Access Compliance Report

Public Rights-of-Way

(Curb Ramps)

Intersection ID: 31697	Main Street: ATLAS_CEDAR_DR	Cross Street: ROBINSON_CHURCH_RD	Location: SW
ADA ID: AEAC598E3603	Ramp Type: Perp	Initial Pass/Fail: Fail	Overall Compliance: No
Severity Score: 21.25			
Codes/Mitigation Info/Possible Solution		Field Measurements/Component Compliance

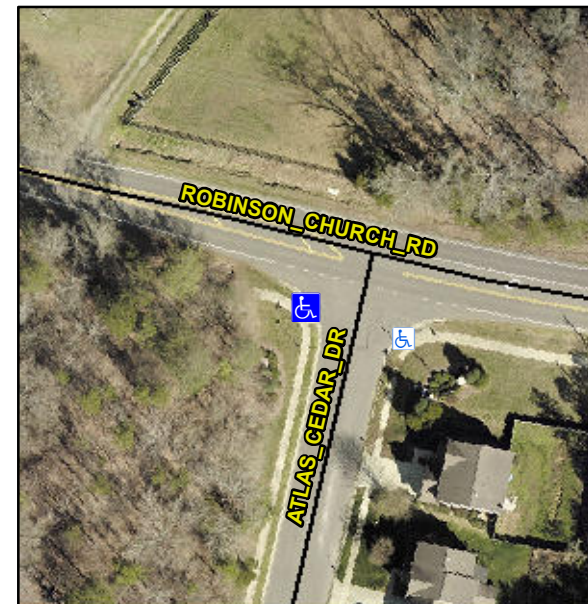
R304.5.1, R304.2.2

Compliance	Description	Data	Compliance	Description	Data
N/A	Ramp Length (in)	48.0	No	Ramp Slope (%)	8.6
No	Ramp Width (in)	40.0	Yes	Ramp XSlope (%)	1.8
N/A	Flare Type LT	N/A	N/A	Flare Type RT	N/A
N/A	Flare Slope LT (%)	N/A	N/A	Flare Slope RT (%)	N/A
N/A	Flare Traversable LT?	N/A	N/A	Flare Traversable RT?	N/A
N/A	Landing Length (in)	N/A	N/A	DWS Provided?	N/A
N/A	Landing Width (in)	N/A	N/A	DWS Contrast?	N/A
N/A	Landing Slope (%)	N/A	N/A	DWS Length (in)	N/A
N/A	Landing X Slope (%)	N/A	N/A	DWS Full Width?	N/A
N/A	Landing Curb? (Y/N)	N/A	N/A	DWS Offset (in)	N/A
N/A	Shared Landing?	N/A			
N/A	Gutter Ponding?	N/A	N/A	Gutter Slope (%)	N/A
N/A	Gutter Lip Ht (in)	N/A	N/A	Gutter X Slope (%)	N/A
N/A	Painted X Walk1?	No	N/A	Painted X Walk2?	N/A
	X Walk 1 Direction	To SE		X Walk 2 Direction	N/A
N/A	X Walk 1 Width (in)	N/A	N/A	X Walk 2 Width (in)	N/A
	X Walk 1 Slope (%)	9.6		X Walk 2 Slope (%)	N/A
	X Walk 1 X Slope (%)	9.1		X Walk 2 X Slope (%)	N/A

Remove & Replace Entire Ramp.
